#### LARAMIE COUNTY PLANNING & DEVELOPMENT DEPARTMENT

#### **MEMORANDUM**

TITLE: PUBLIC HEARING regarding a Subdivision Permit and Plat for Diamond

Hills, located in a portion of the NW1/4 NW1/4, Section 29, T.14N., R.60W.,

**Attachment 9: Plat**

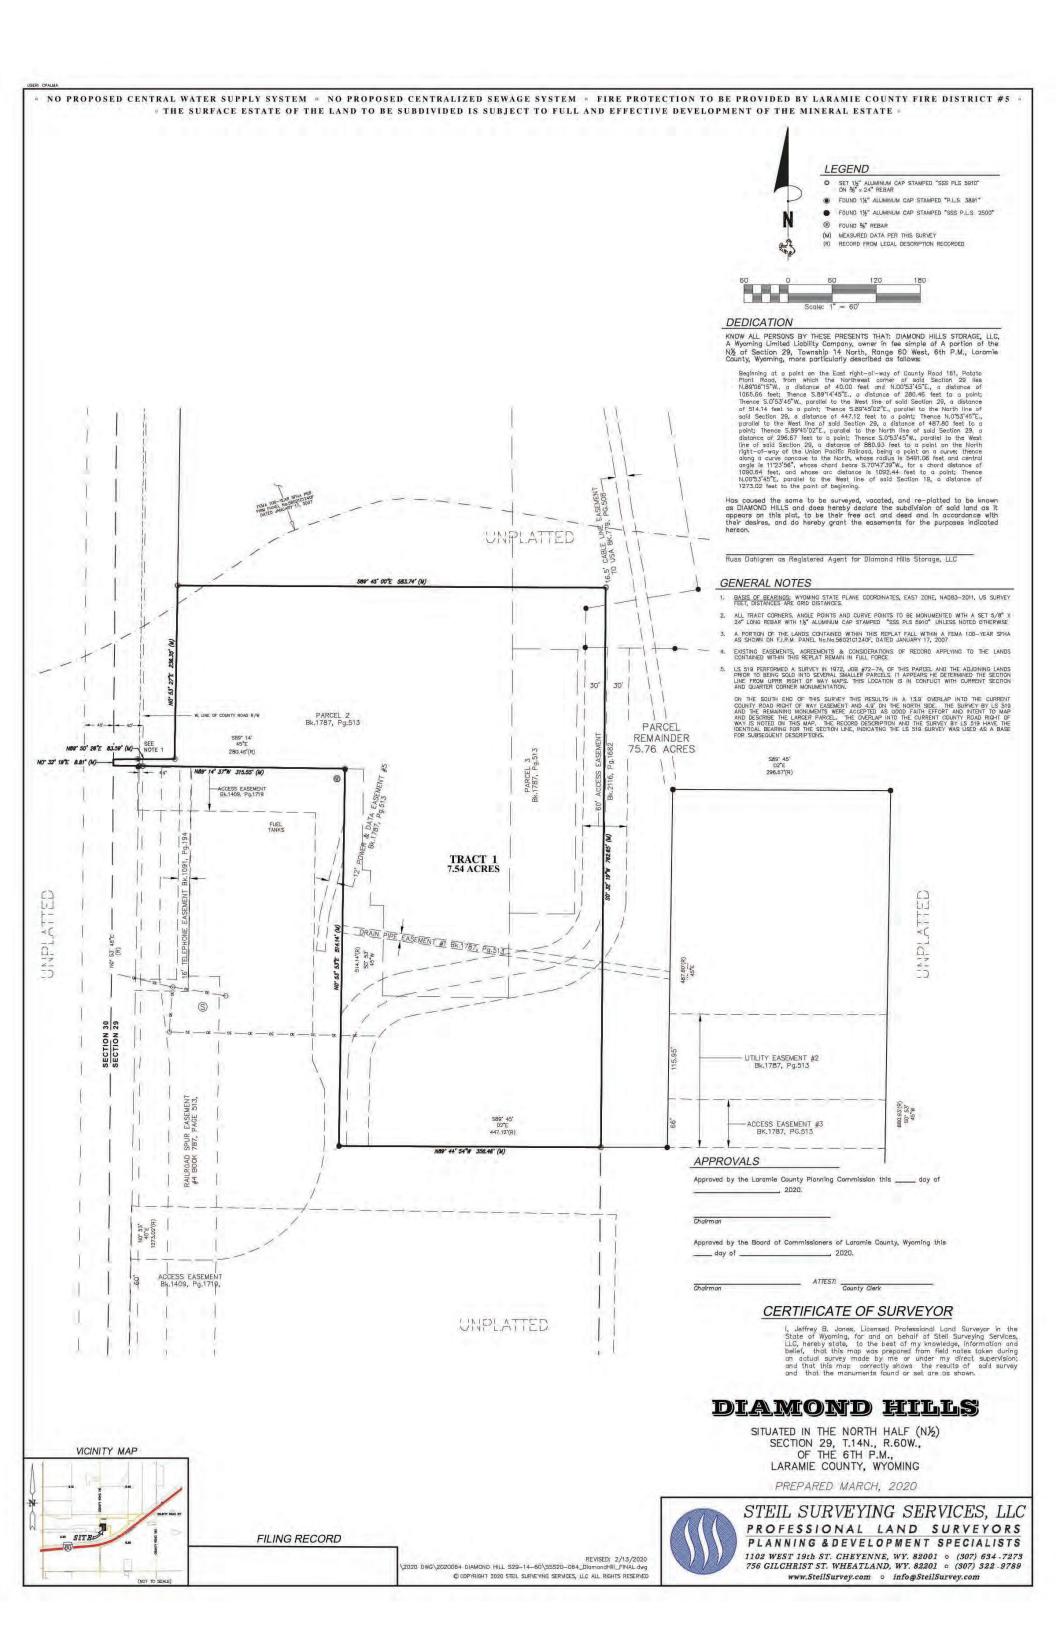
- 1. It would be helpful if CR 161 was labeled on the plat.
- 2. There are several line types shown that are not identified and it would be helpful if the legend included the line types.
- 3. I concur with the request for a waiver of a detailed Traffic Study and Drainage Study based on the information provided with the application.

- 1. It would be helpful to label the Point of Beginning and the tie to the Northwest corner of Section 29, with both being referenced in the legal description included in the DEDICATION. As currently shown on the plat, the bearings and distances called out in said legal description are a little confusing when they are placed next to the TRACT 1 boundary bearings and distances.
- 2. There are no State Plane Coordinates shown on the plat.
- 3. There is no "Statement to Vacate" shown on the plat. The DEDICATION states "Has caused the same to be surveyed, vacated and re-platted".
- 4. There are several instances where "the location of the recorded rights-of-way intersecting the boundary of the subdivision" are not shown.
- 12' POWER AND DATA EASEMENT EASEMENT #5, BK 1787, PG 513 DRAIN PIPE EASEMENT #1, BK 1787, PG 513

Need notary statement for Diamond Hills Storage LLC.

In the title block add PTN... Situaten in a Portion of the North Half...

- 1. The legal description, stated in both the Dedication and the title should be updated from the north half to include quarter quarters, to read "Situated in the NW1/4 NW1/4, Section 29, T.14N., R.60W., of the 6th P.M., Laramie County, WY.
- 2. The letter 'A' is capitalized unnecessarily several times in the Dedication, please correct.
- 3. The plat states that the it was prepared March, 2020, however the Revised date states 2/13/2020. This will need to be updated as the revision date cannot take place before the preparation date.

- 4. The Dedication states "Right-oi-way", please correct.
- 5. As this is a Subdivision Permit & Plat, rather than an Administrative Plat the signature blocks for the Planning Director and the Public Works Director need to be removed and spaces for the Planning Commission Chairman and the Board of County Commissioners Chairman added. These blocks must be directly adjacent to the right or bottom border of the plat. There also needs to be a signature block for the County Clerk added.

- 6. A statement must be added to the plat indicating the type of sewage disposal, the type of water supply, and the type of fire protection proposed for the subdivision.

- 7. Because Potato Plant Road is not an official county road, it should be removed from all language on the plat.
- 8. In the Dedication the number 19 has been hand-corrected to 29, please correct.

- 9. The Filing Record box must be completely clear of any wording.
- 10. There is no Statement to Vacate on the plat. This must be titled and stated clearly on the plat.

- 11. The Railroad Spur Easement #4 state Book 787, Page 513. Should the book number be 1787 as all the other records are?
